COBRA Guidance Note

The purpose of this Product Guidance Note is to share various (mostly minor) issues which have occurred recently and provide information relating to future changes.

Figure 5 - Piston Assembly Showing Positive Pressure Rod

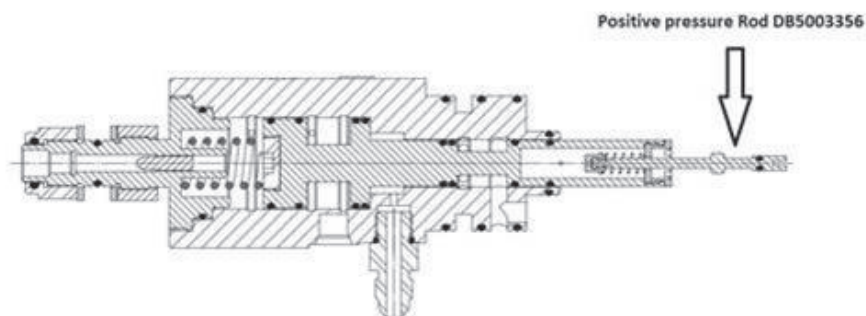
Various reports have been received relating to bending of the positive pressure rod DB5003356.

Likely reasons for bending to this rod are adjusting the demand valve setting via the diaphragm opening or manually purging the set to drain the cylinders more quickly. If either of these techniques is used, care must be taken to not damage the positive pressure rod.

Figure 10 - Diver Face Down, Easy Exhale, Harder Inhale

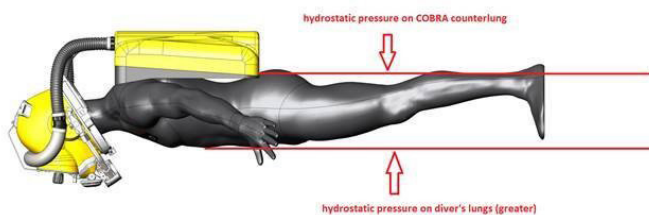
Users have reported increased breathing resistance when using COBRA in various orientations.

This is a well understood characteristic with all rebreathers. A proportion of the required breathing effort is caused by the pressure difference between the user's lungs and the current relative position of the rebreather counterlungs. For example, if a diver (using COBRA) is on his front, the counterlungs are higher in the water column i.e. at a lower pressure than the diver's lungs. The diver will have to work harder to fill his lungs with gas. Conversely, if the diver is on his back, the counterlungs will be at a higher pressure and the diver may well require extra effort to exhale. Other positions, of course, lie between these extremes.
